In Reply Refer To:
HSSI/WZ-25A

This is in response to your October 7 correspondence requesting the Federal Highway Administration's (FHWA) acceptance of your company's Model FS2000W portable sign stand as a crashworthy traffic control device for use in work zones and elsewhere on the National Highway System (NHS). Accompanying your letter was the FHWA Office of Safety Design form explaining the change from a coiled spring (as in the Model UF2000W stand accepted in WZ-25) to a flat one. You requested that we find this device acceptable for use on the NHS under the provisions of National Cooperative Highway Research Program Report 350 "Recommended Procedures for the Safety Performance Evaluation of Highway Features."

This inquiry is in regards to a modified version of the previously accepted UF2000W sign stand (HAS-1/WZ-25). The new version of this stand FS2000W replaces the coiled spring with a flat steel spring. The stand footprint is the same while the top of the sign bracket is actually lower. The stand specifications may be found in Table #1 below and in the attached drawings.

#2d - UF2000W / FS2000W Side by Side Comparison

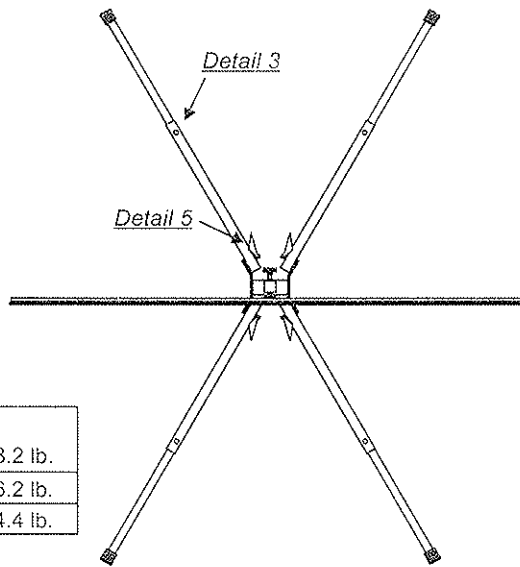
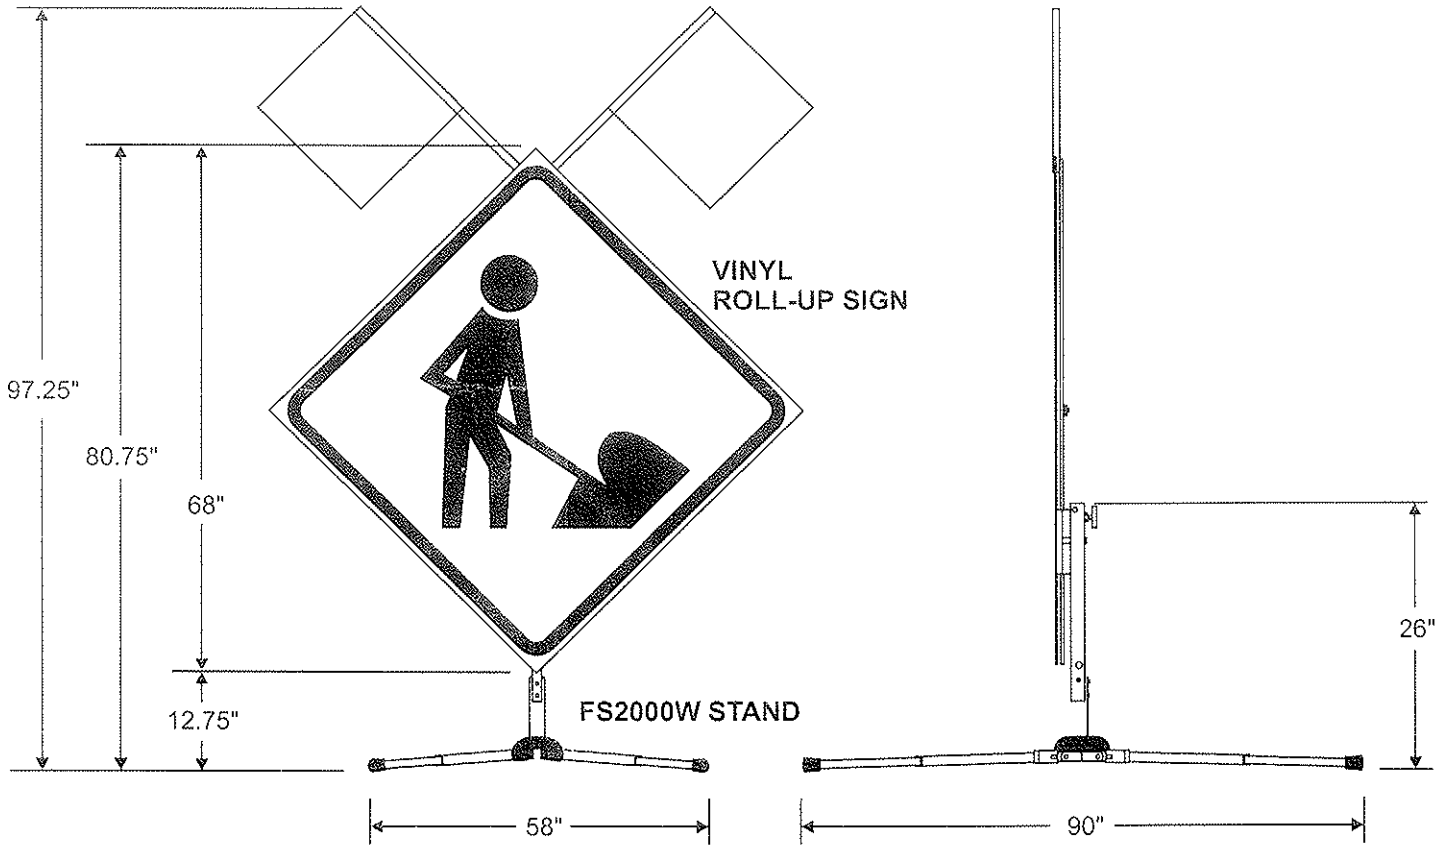
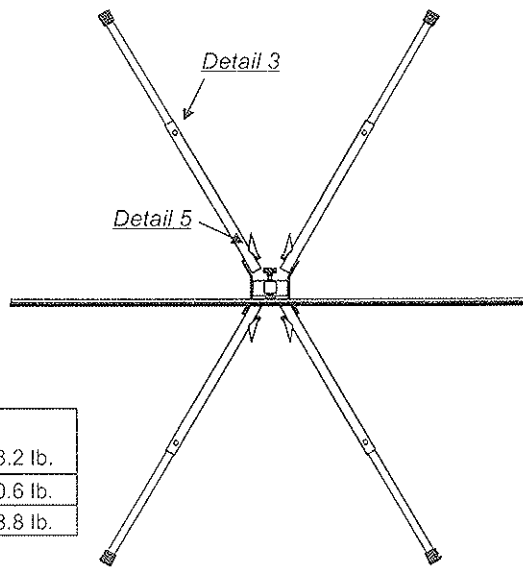
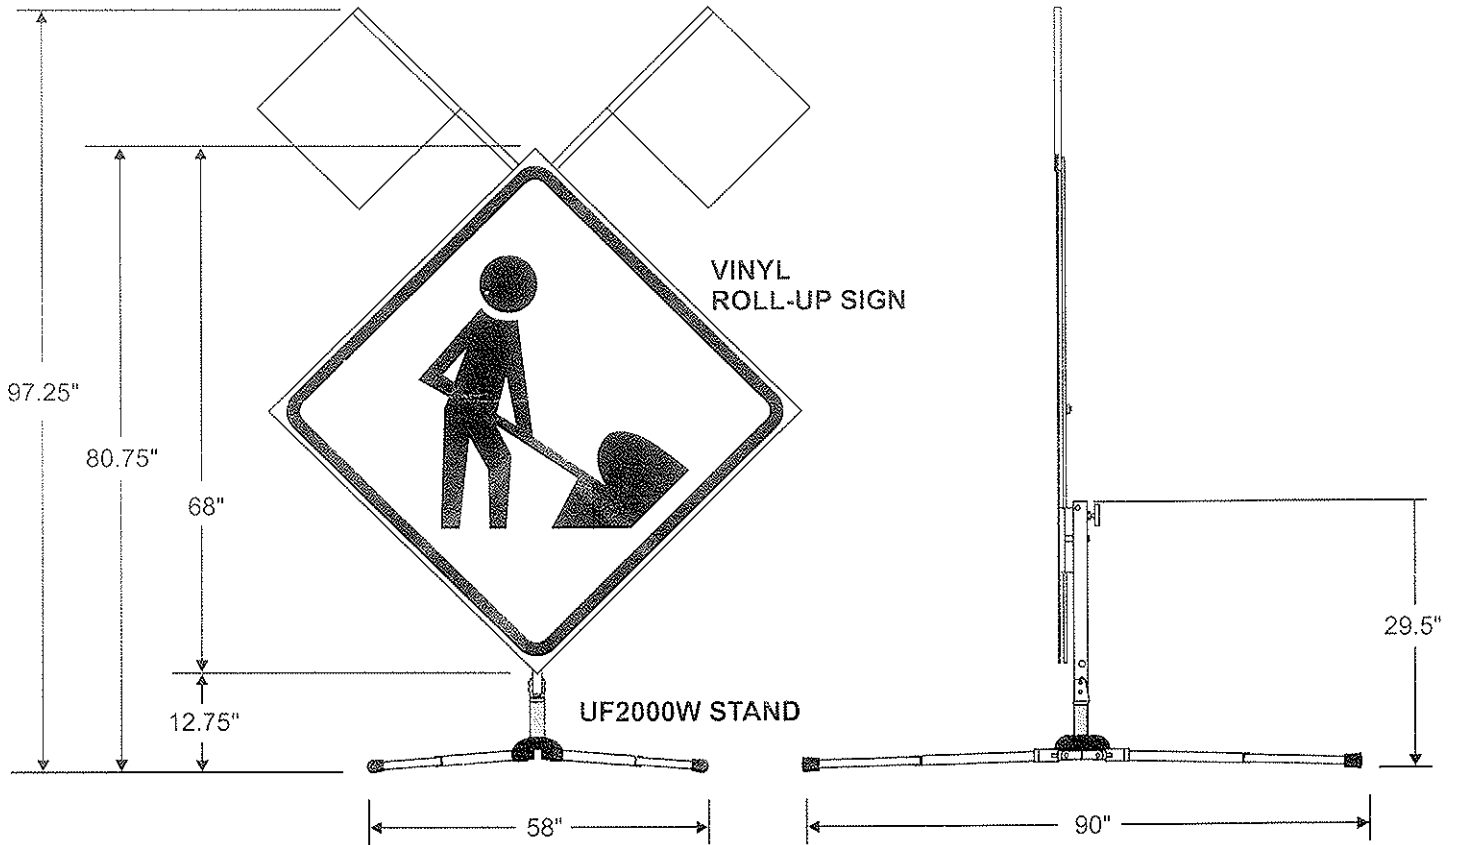
Based on the enclosed information and previous test data, we are seeking acceptance of sign stand FS2000W. We believe this to be a reasonable request because the design differences all occur below the height of the vehicle bumper. As such, we contend that they will have no effect on the windshield impact data.

This letter is the acknowledgement of the FHWA's acceptance of your request. The original completed form has been modified by the addition of the FHWA acceptance letter number and the date of our review. The form, of which a copy is enclosed for reference, will be posted on our Web site in the near future.
